MODIFICATION No.2

Title-Sujet Remplacement du pont du barachois Rocky – PN du Gros-Morne		
Solicitation No. - No. de l'invitation 5P201-18-0213/A		Date: 29 janvier 2019
GETS Reference No. – No de référence de SEAG PW-19-00859693		Client Ref. No. – No. de réf du client. 1845
Solicitation Closes – L'invitation prend fin :		
at – à 14h00	on – le 5 février 2019	Time Zone - Fuseau horaire EST - HNE
F.O.B. - F.A.B. Plant-Usine: <input type="checkbox"/> Destination: <input checked="" type="checkbox"/> Other-Autre: <input type="checkbox"/>		
Address Inquiries to: - Adresser toute demande de renseignements à : Michel Marleau michel.marleau@canada.ca		
Telephone No. - No de téléphone (613) 938-5822		Fax No. – No de FAX:
Destination of Goods, Services, and Construction: Destinations des biens, services et construction: See Herein – Voir aux présentes

MODIFICATION #2

GENERAL ARRANGEMENT SHEET 1 of 2

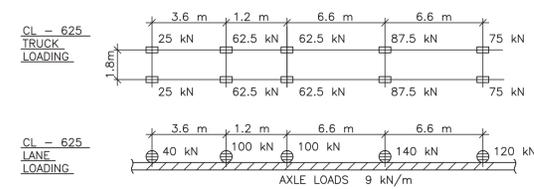
Drawing S1 - General Arrangement Sheet 1 of 2, Revision 1, Issued for Addendum, 01/24/2019.

drawing design
BRIDGE EXCAVATION AND FILL QUANTITIES

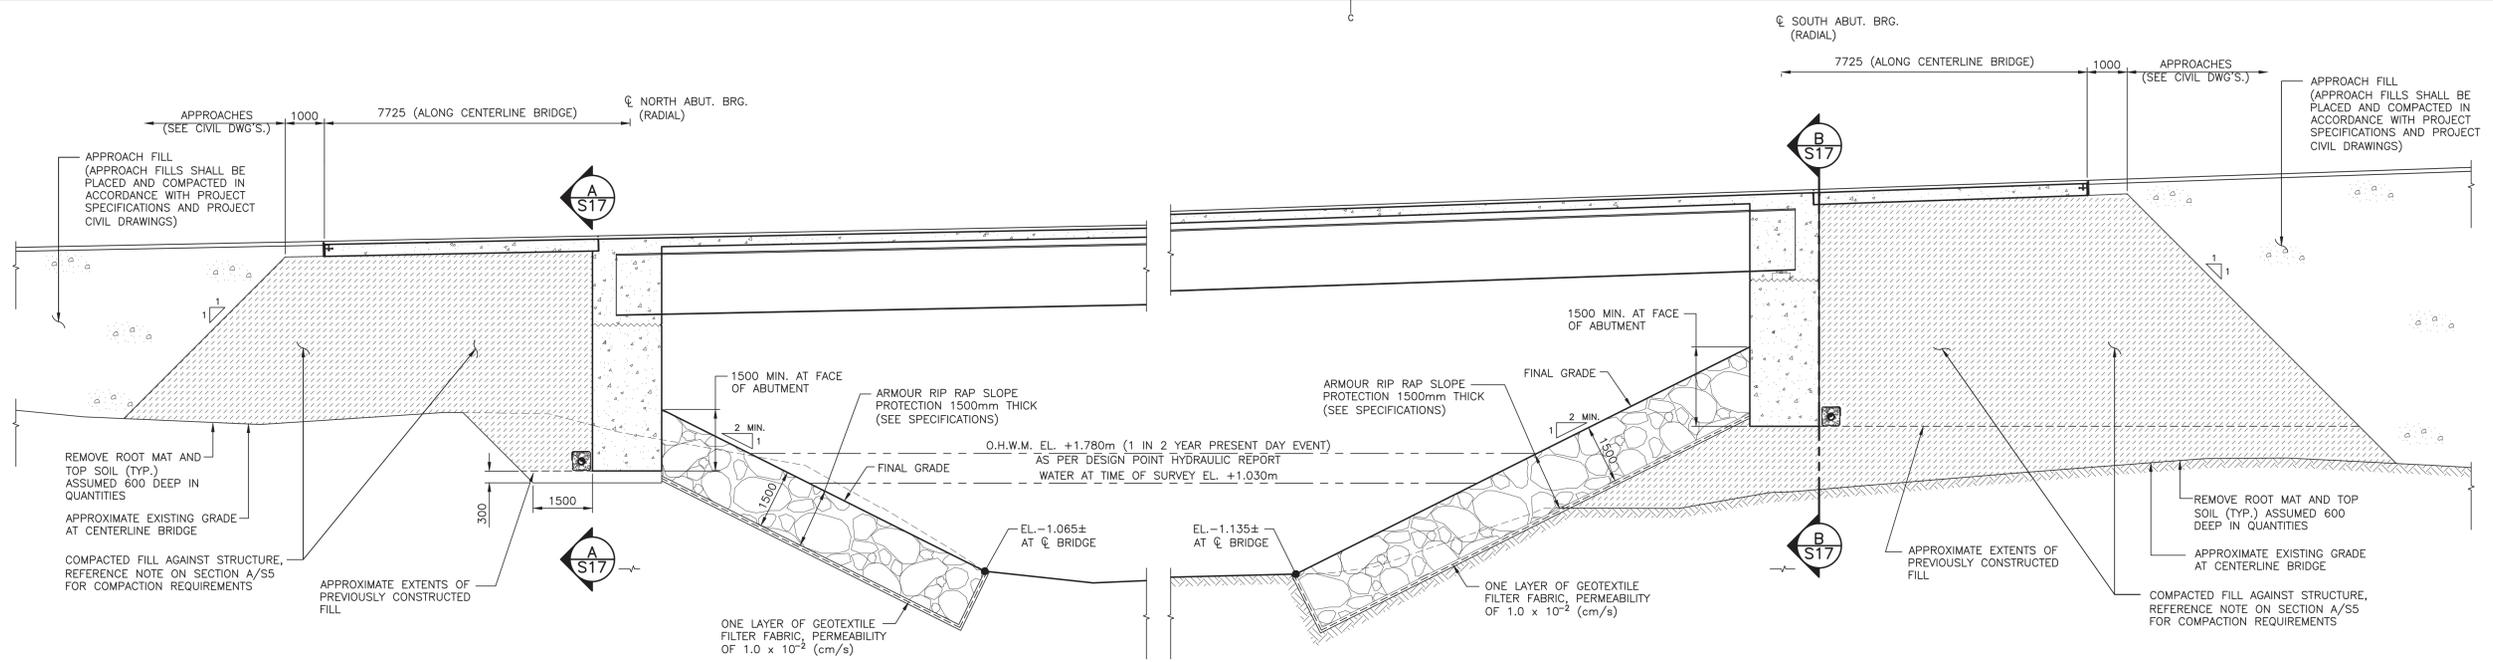
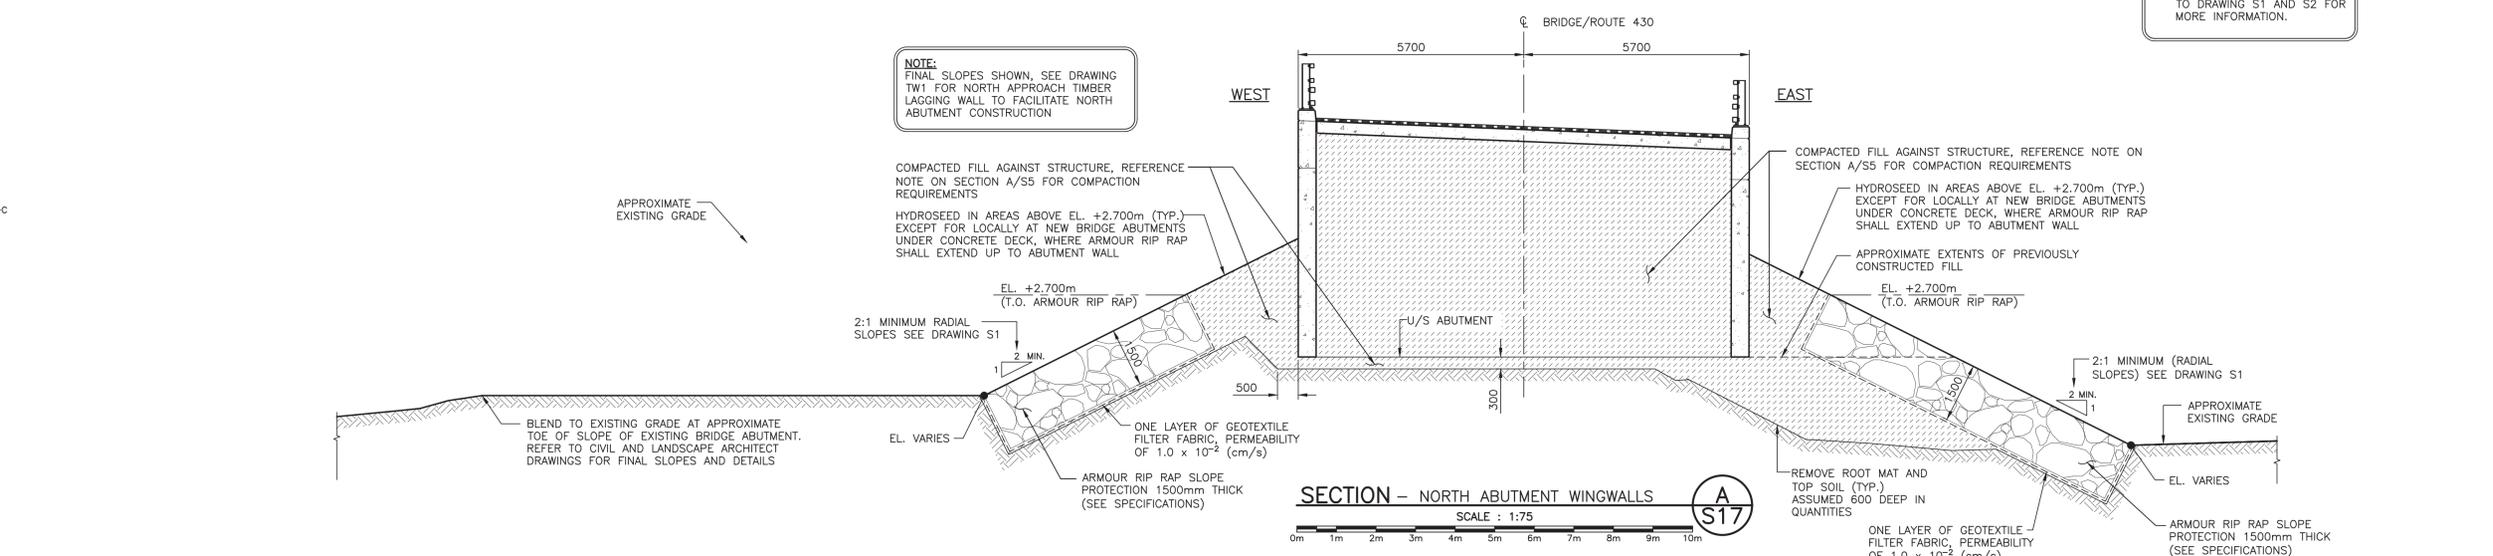
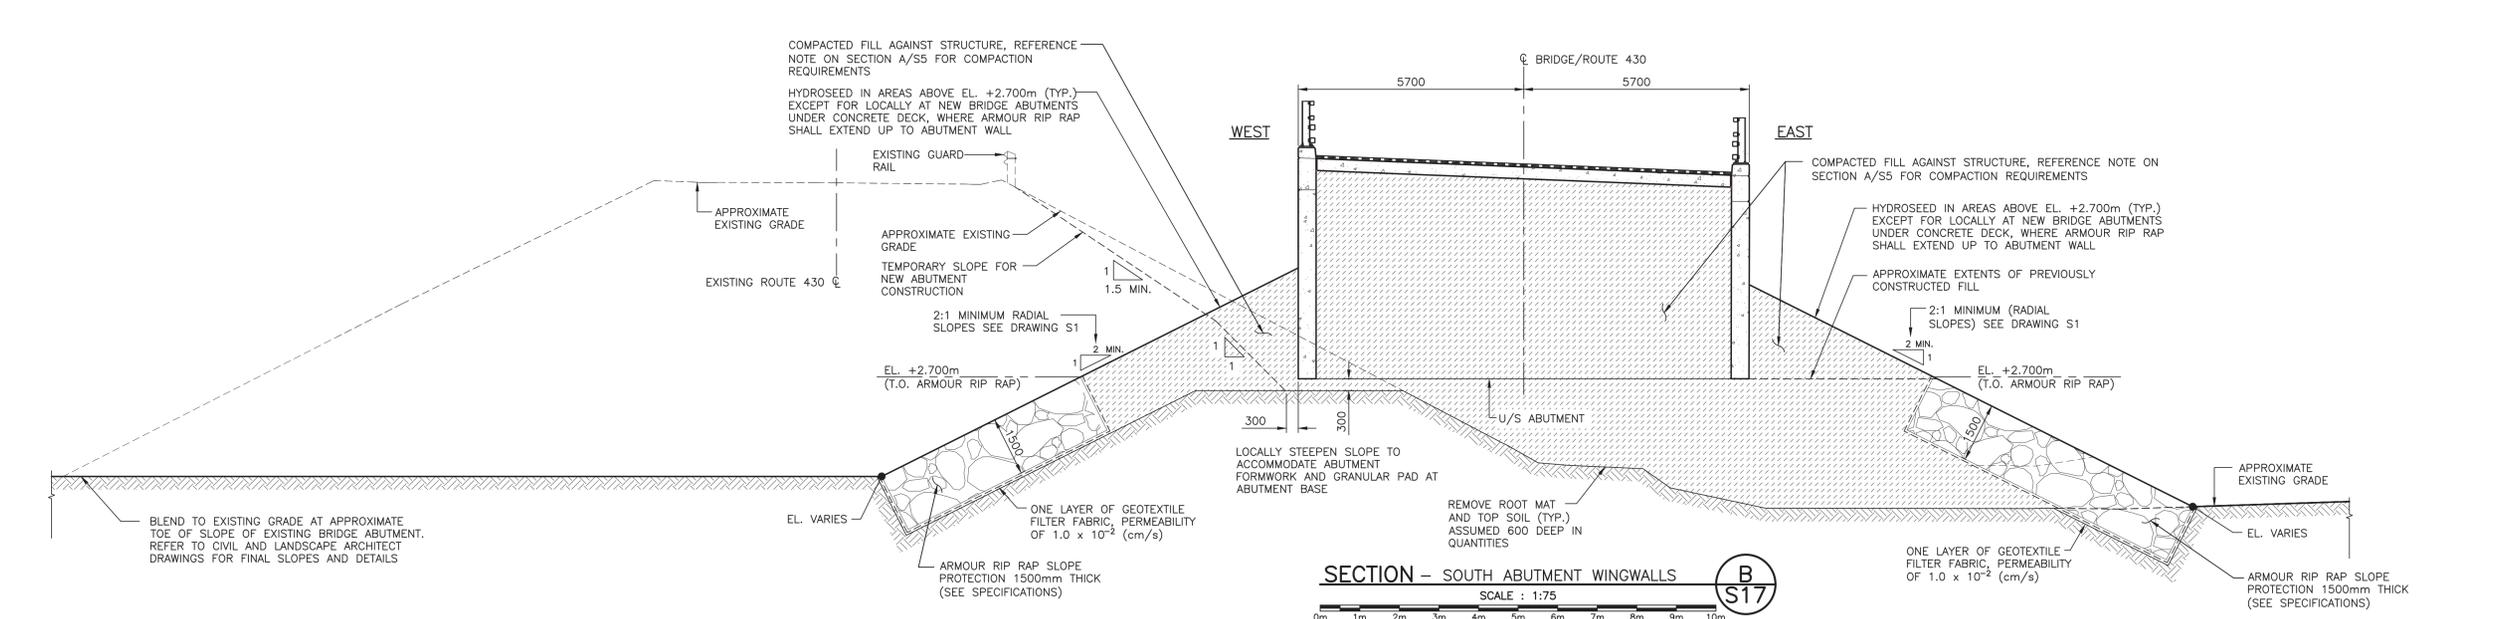
Drawing S17 - Bridge Excavation and Fill Quantities, Revision 1, Issued for Addendum, 01/24/2019.

drawing
BOX GIRDER LAYOUT PLAN AND SECTIONS
design

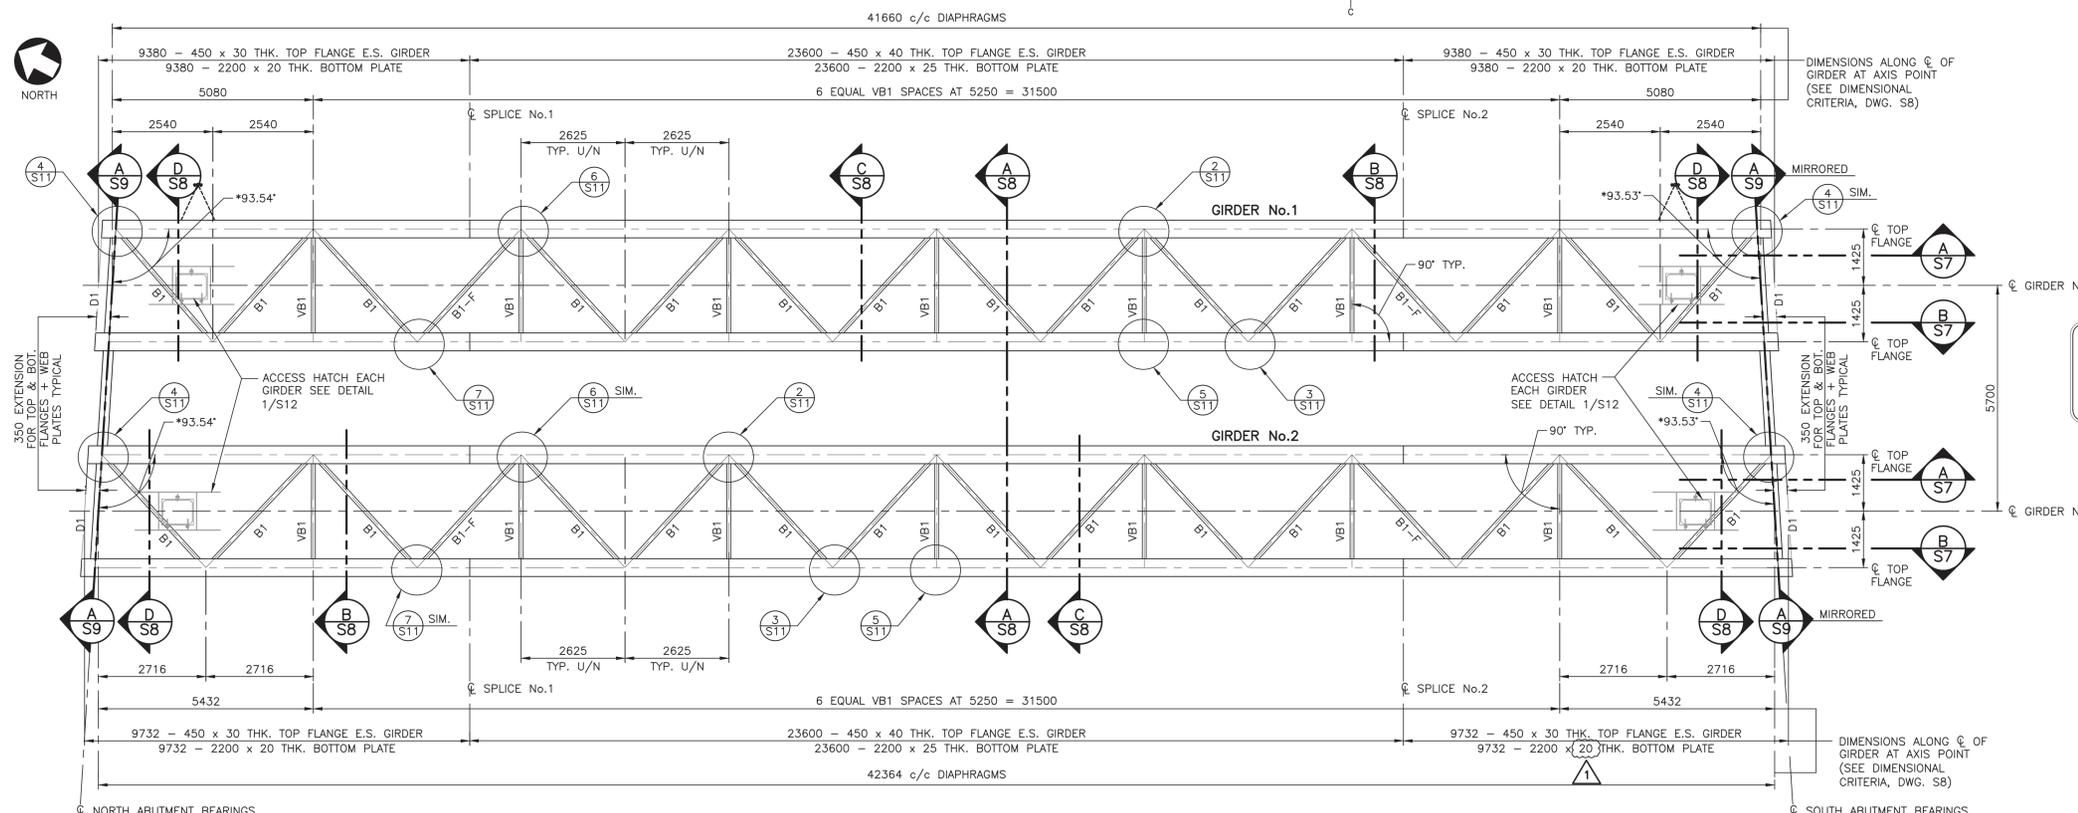
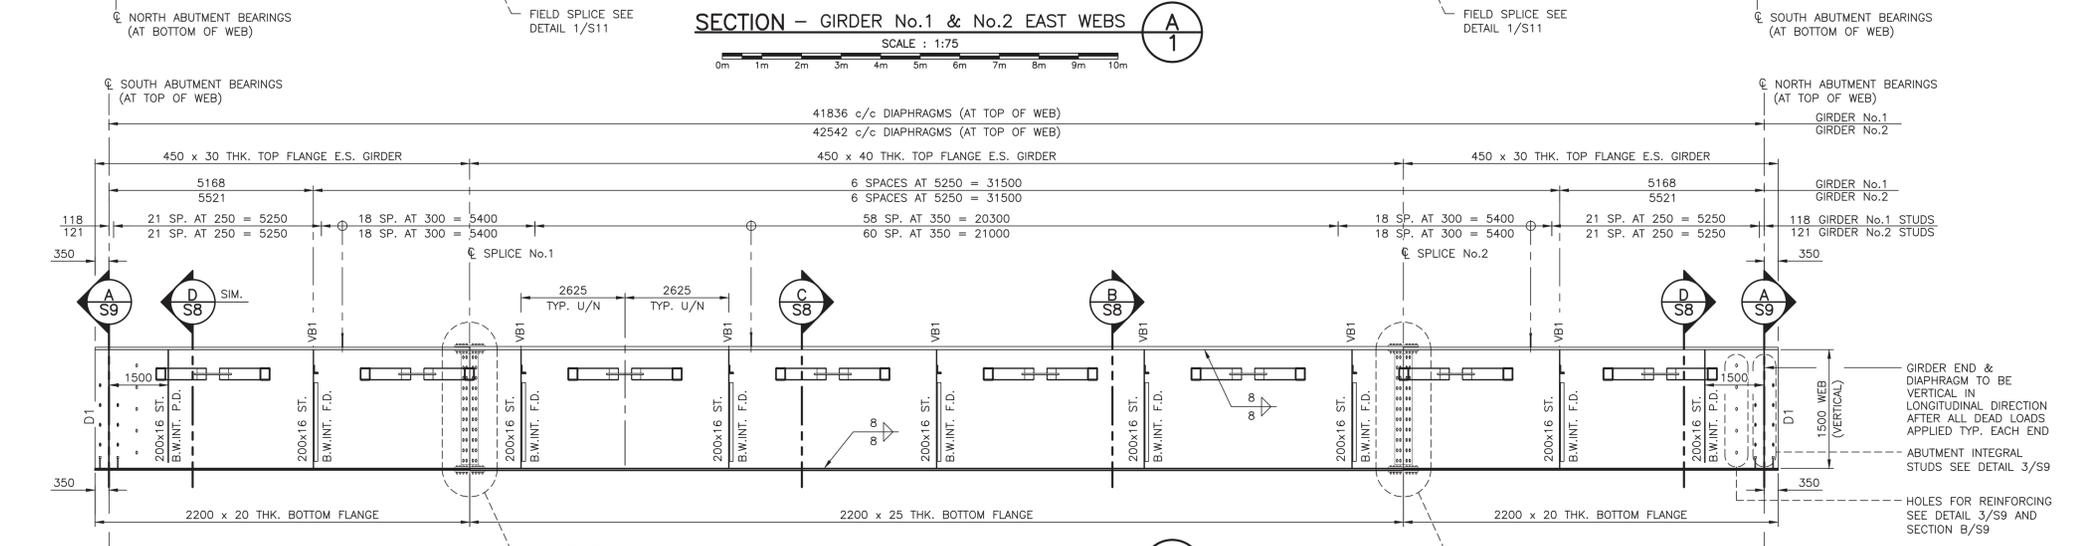
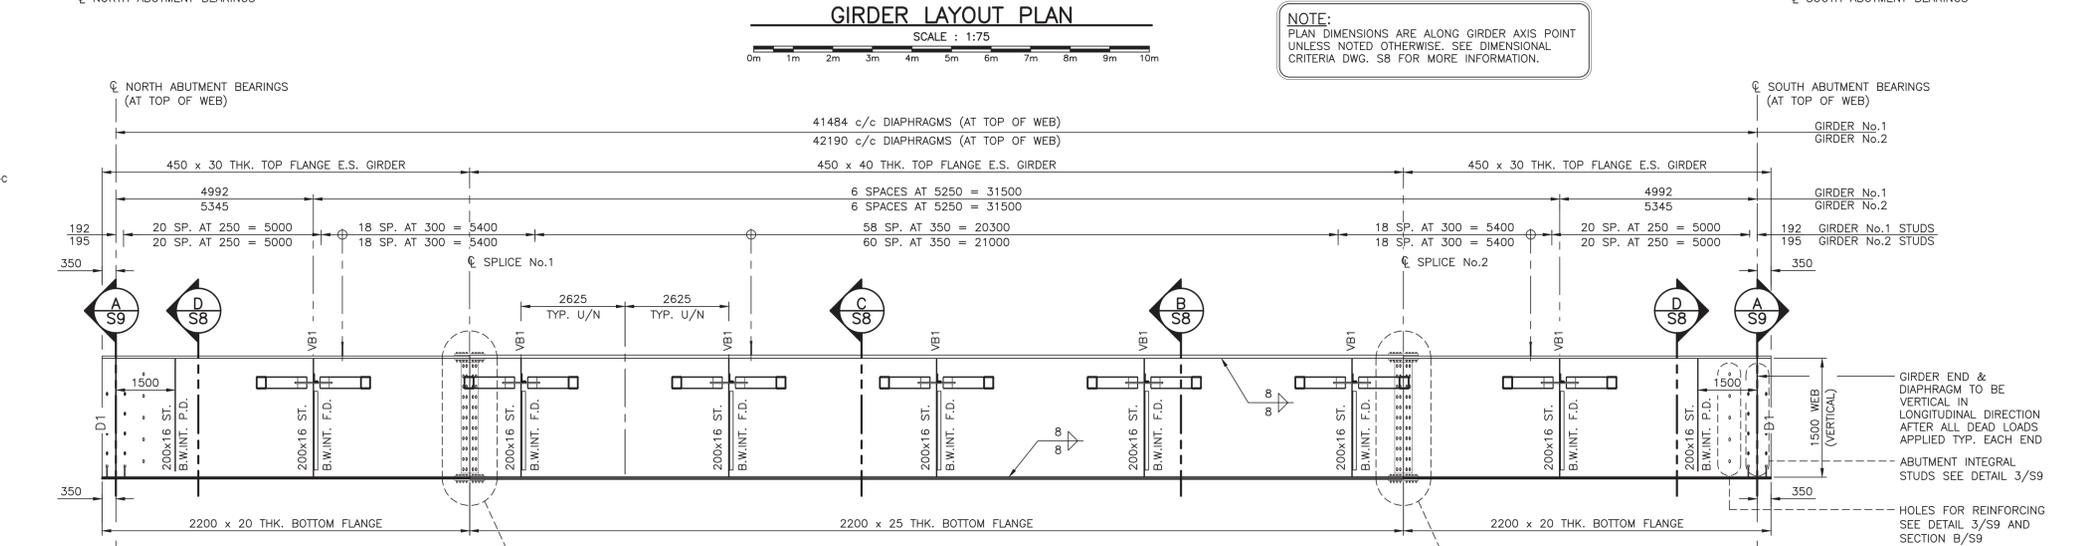
Drawing S7 – Box Girder Layout Plan and Sections, Revision 1, Issued for Addendum, 01/24/2019.

Q2. Au dessins S7, sur la vue « Girder layout plan », la plaque inférieure de la poutre No. 2, côté Sud est montrée à 25mm d'épaisseur, alors que sur la section B au bas de la page elle est montrée à 20mm d'épaisseur, Est-ce que l'épaisseur de la plaque inférieure pourrait être confirmé?

R2 : Voir le dessin S7 ci-joint avec la révision 1 notée pour corriger l'épaisseur de l'acier.
